Agenda  
Village of Glen Ellyn  
Special Meeting  
Monday, December 18, 2017  
7:00 PM  
Glen Ellyn Civic Center, Room 301

**H. Taylor Avenue Pedestrian Tunnel Project (Professional Engineer Daubert) (Trustee Kenwood)**

**1. Motion to increase the appropriation for Phase II engineering services associated with the Taylor Avenue Pedestrian Tunnel Project provided by Alfred Benesch & Company in the amount of \$34,105 for a revised total appropriation of \$189,565 to be expensed to the Capital Projects Fund. 2. Motion to authorize the Village Manager to execute Change Order No. 2 to the Phase II engineering services agreement with Alfred Benesch & Company for the Taylor Avenue Pedestrian Tunnel Project for additional investigations and analyses in the amount of \$34,105 resulting in a revised total fixed price of \$189,565.**

**From:** O'Connor, Michael  
**To:** [Richard Daubert](#)  
**Cc:** [Keaschall, Andrew](#)  
**Subject:** Village of Glen Ellyn Taylor Ave. - Supplement to Address New Conditions  
**Date:** Thursday, December 07, 2017 10:13:06 AM  
**Attachments:** [10507 - Glen Ellyn Scope Change Spreadsheet.pdf](#)  
[Glen Ellyn Scope Change Attachment Exhibits.pdf](#)  
[

**PLAN VIEW**  
(At completion of future track and structure widening)

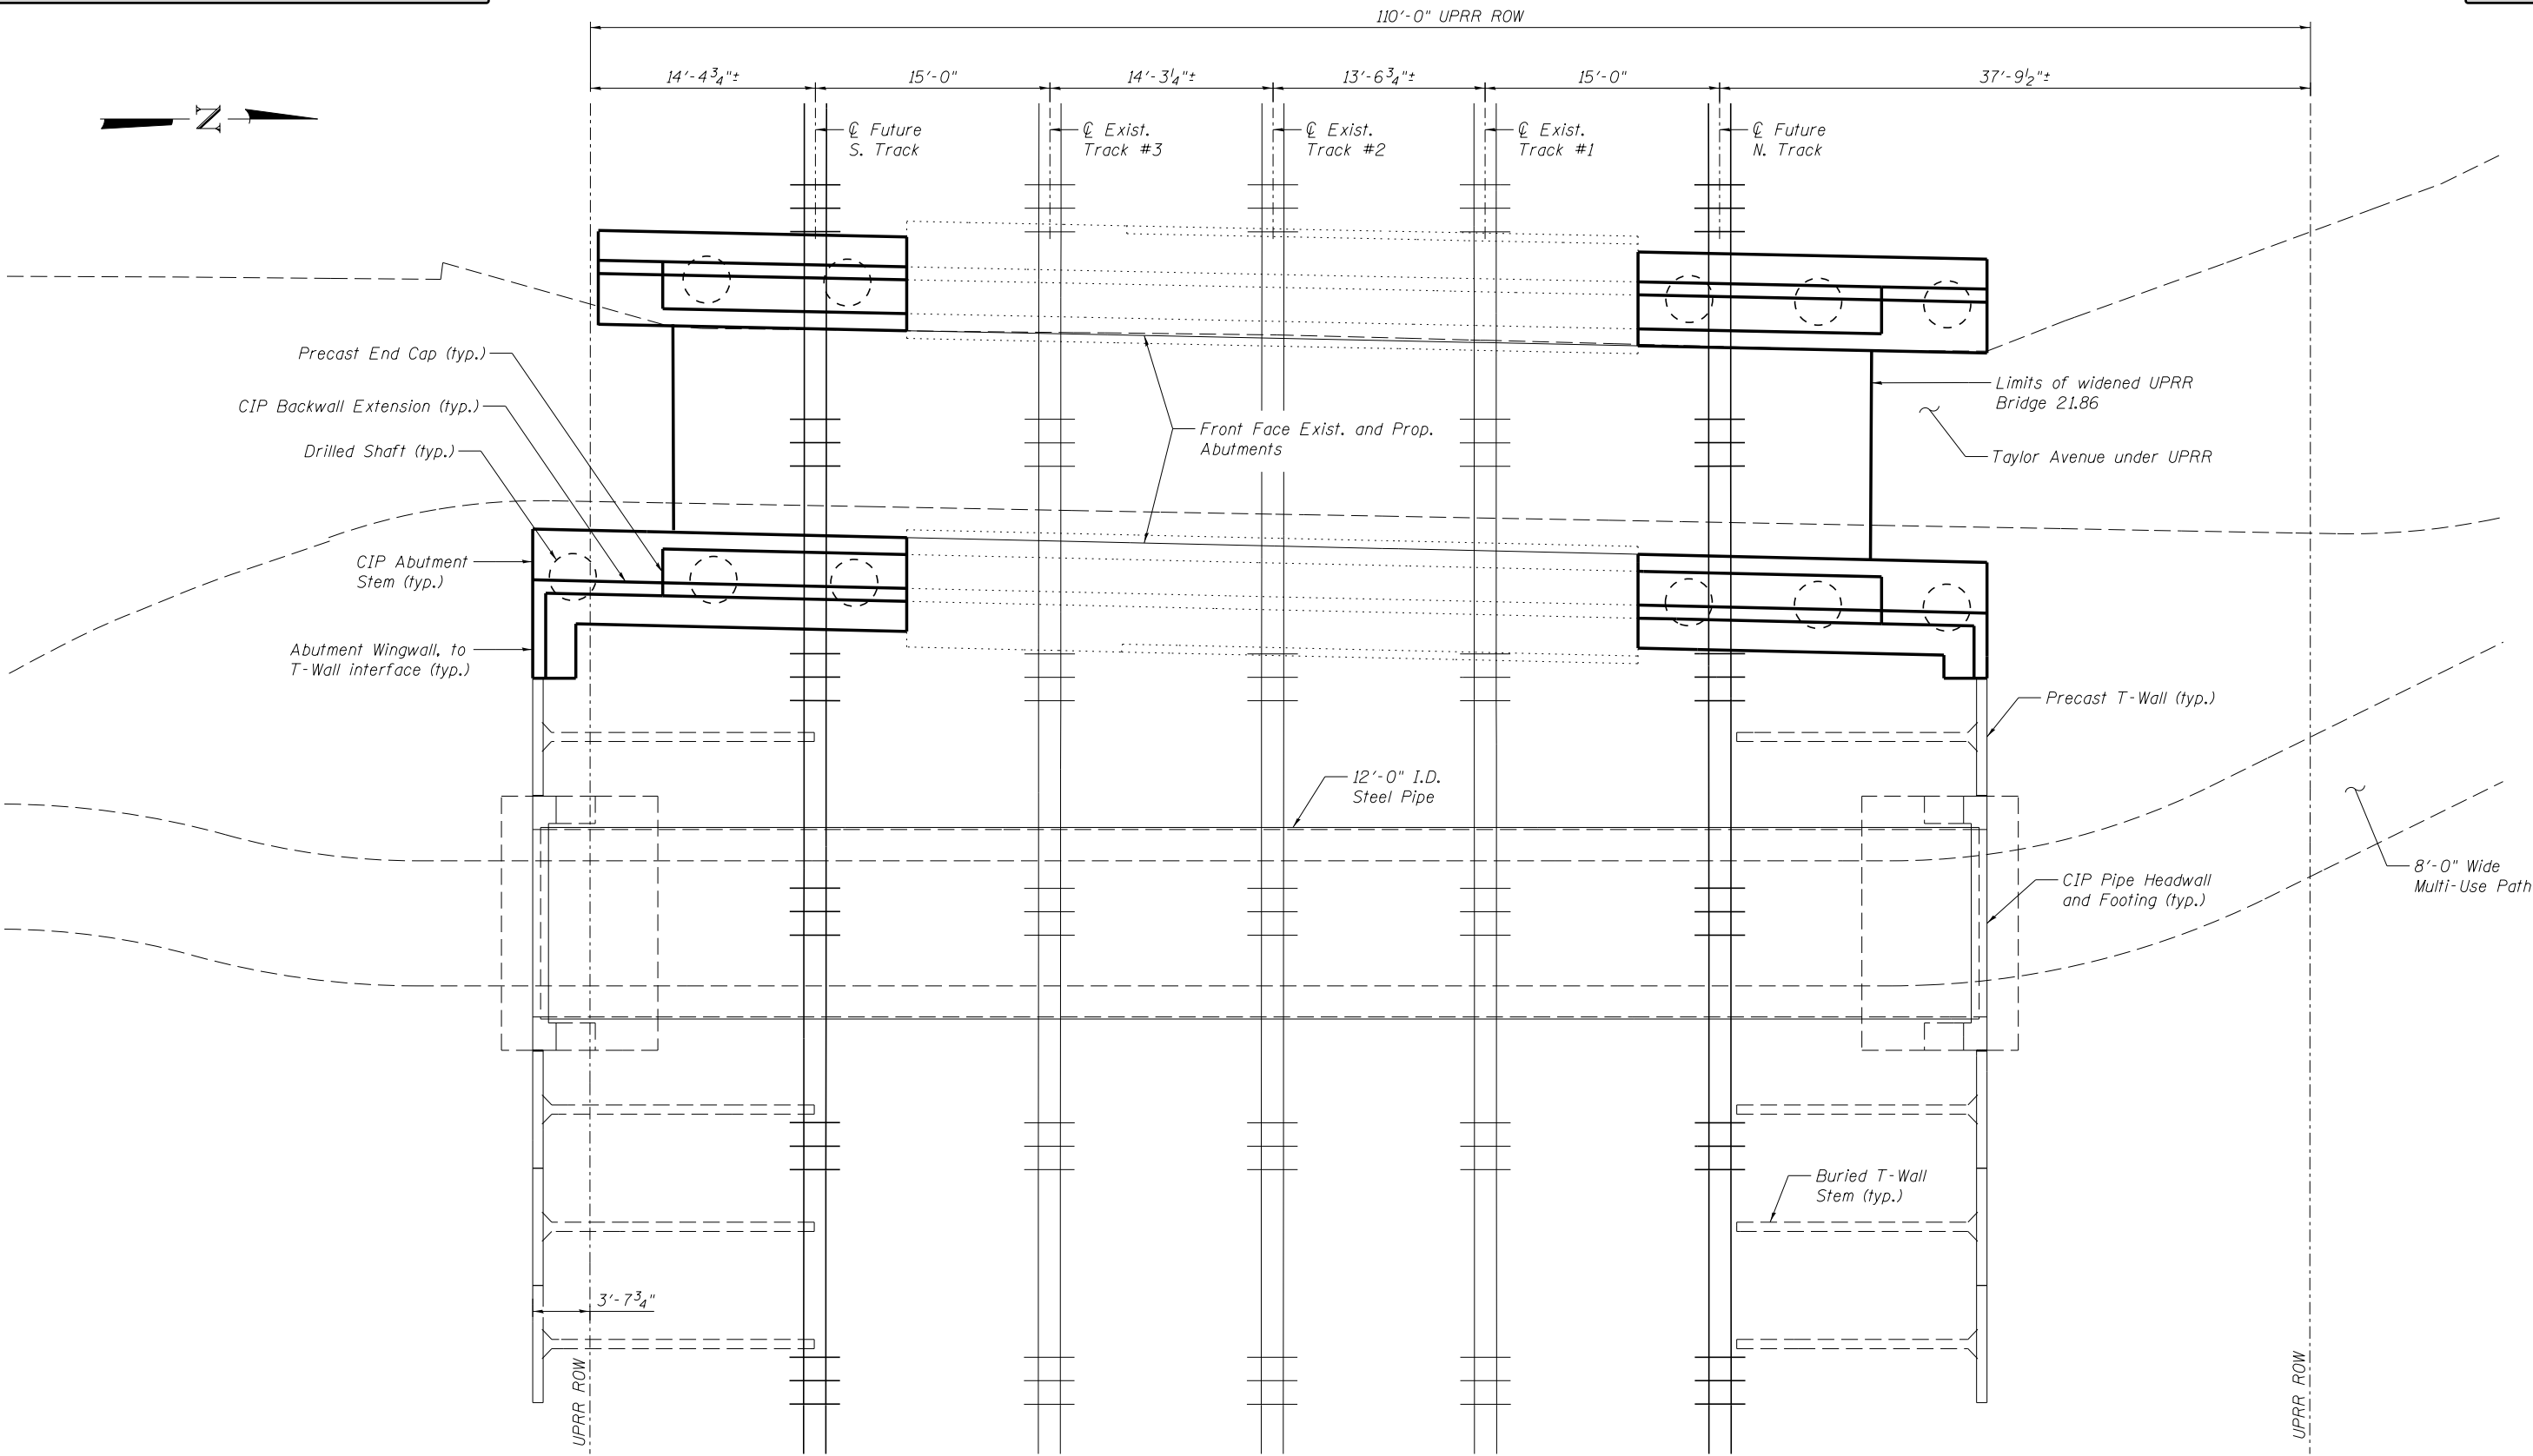
**Sheet 4: Future Permanent Condition (After Track Widening)**

- This sheet shows the final condition after the UPRR bridge substructure and superstructure has been widened to support an additional south and north track.
- A wingwall extension behind the proposed widened abutment can be used to close any gap between the T-Wall and the new bridge substructure.
- Note that on the south tunnel side of Taylor Avenue, the UPRR bridge substructure is shown to extend off the UPRR ROW to line up with the front face of the T Wall. If it is required for any future UPRR construction to stay within the UPRR ROW, the entire T-Wall may need to be shifted inside the UPRR ROW (via method discussed in Sheet 2 comments).

**SOUTH T-WALL ELEVATION - AFTER TUNNELING PROJECT (BEFORE BRIDGE WIDENING)**  
(Looking North)

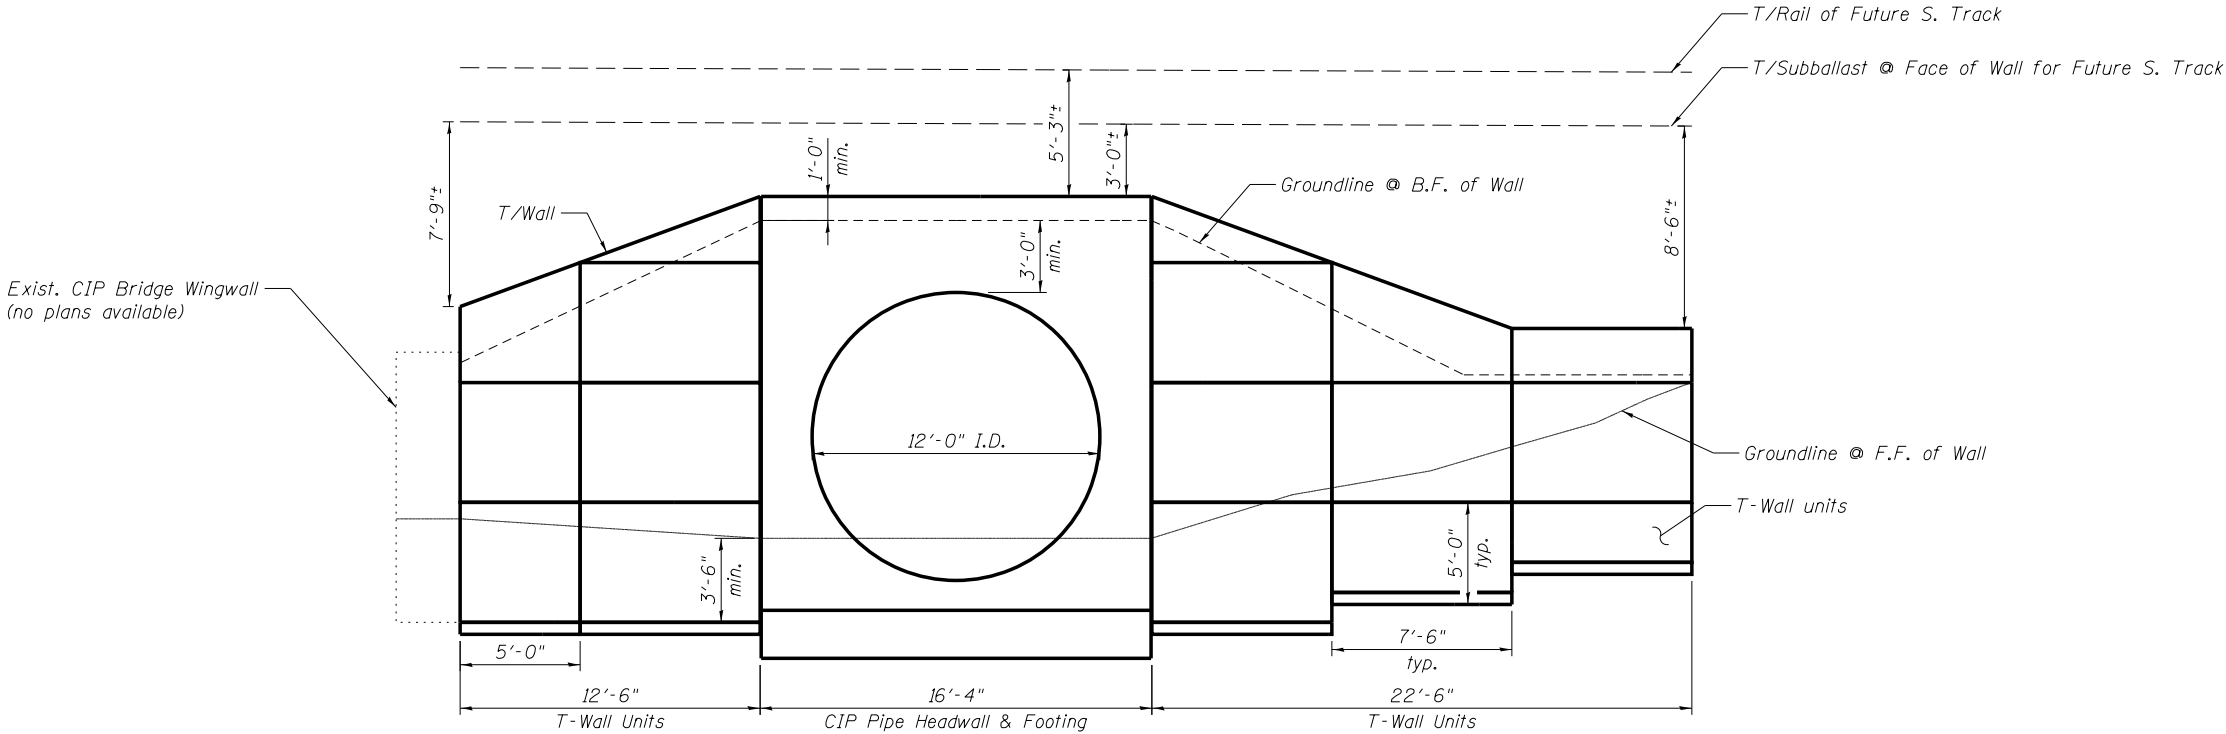
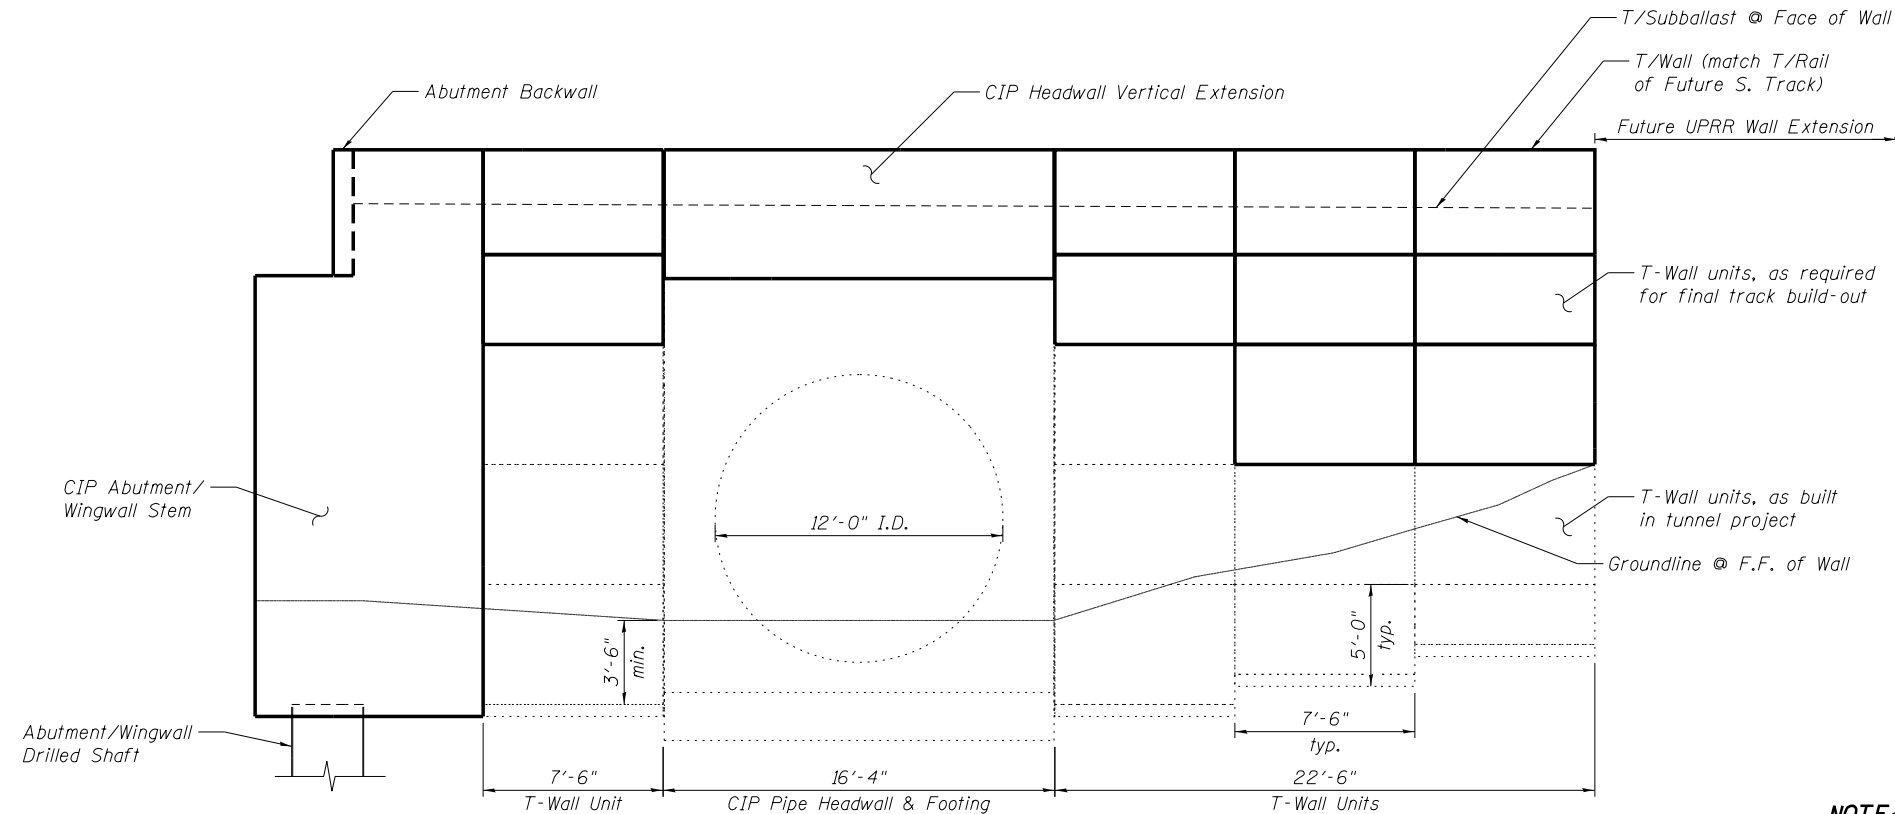
**Sheet 5: T-Wall Elevation After Tunneling & After Bridge Widening**

- This sheet shows an elevation view of the south wall after completion of the current proposed tunneling project along with an elevation view for one concept to complete the abutment and wall during a future bridge widening project.
- Note that the proposed condition after completion of this tunneling project will place a minimum of 3'-0" of fill over the steel pipe and be graded to meet the existing bridge wingwall elevations as well as the UPRR track slopes away from the bridge.
- The elevation view for a future bridge widening project depicts how additional precast wall units can be stacked on top of the wall units built in the tunneling project to support a future track addition. The bottom wall units will be designed and constructed to support the final built-out elevations and track loading.
